Subject: Response to EPA Information Requests, 2/10/14 and 2/25/14
Air Permit No. 901 PSD TX 1334
OCI Beaumont LLC

Cost Estimate for Implementing Carbon Capture and Sequestration (CCS) Technology OCI Beaumont LLC - Supporting BACT Analysis for Debottleneck PSD GHG Permit

Attachment C
Methanol Production Efficiency Evaluation
OCI Beaumont LLC - Supporting BACT Analysis for Debottleneck PSD GHG Permit

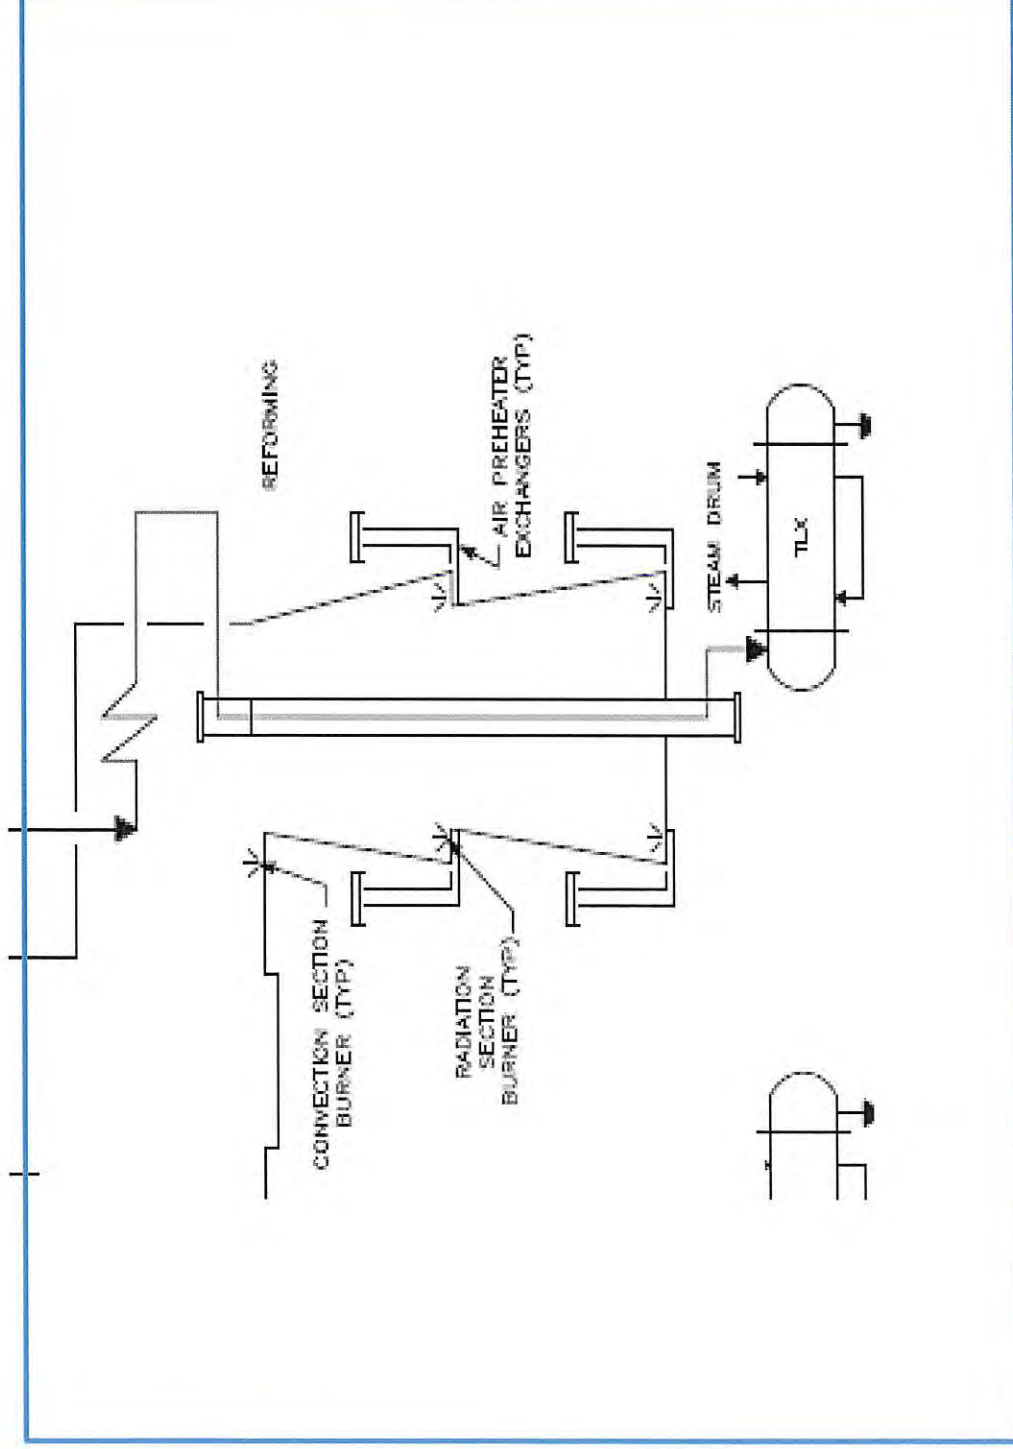
1. Background basis regarding the cost conclusion of \$106.2/tonCO₂ removed on pg F of Appendix B. BACT analyses is a site (case by case) evaluation and not fully dependent on historical 2010 reports. Since CO₂ is used in your process at the plant, I will need the BACT analyses to evaluate the technical and economic feasibility of utilizing CO₂ in the plant.

OCI Response: You requested the cost basis and calculations for the data we provided you in the air permit application for carbon capture and sequestration (CCS) or the stack parameters of the combustion source exhaust gases. A more detailed BACT cost analysis for CCS has been completed and is included as Attachment A.

- a) OCI Total Net Annualized CCS Cost = \$74,525,000 per year = Item 2.e + Item 3.i - Item 4.g
- b) OCI CO₂ Reduction from CCS = 1,000,935 TPY same as CCS capture design capacity
- c) CO₂ from Model CCS Steam Boiler = 245,314 TPY (gas-fired steam boiler required by CCS)
- d) CO₂ from OCI CCS Steam Boiler = 495,500 TPY = Model CO₂ Emissions * Design Capacity Scaling Factor (no incremental efficiency is expected as compared to model)
- e) OCI Net CO₂ Reduction from CCS = 505,400 TPY = Item 5.b - Item 5.d
- f) OCI Control Cost Effectiveness for Implementing CCS = \$147.46 per ton of CO₂ reduced from CCS compared to proposed BACT = Item 5.a / Item 5.e
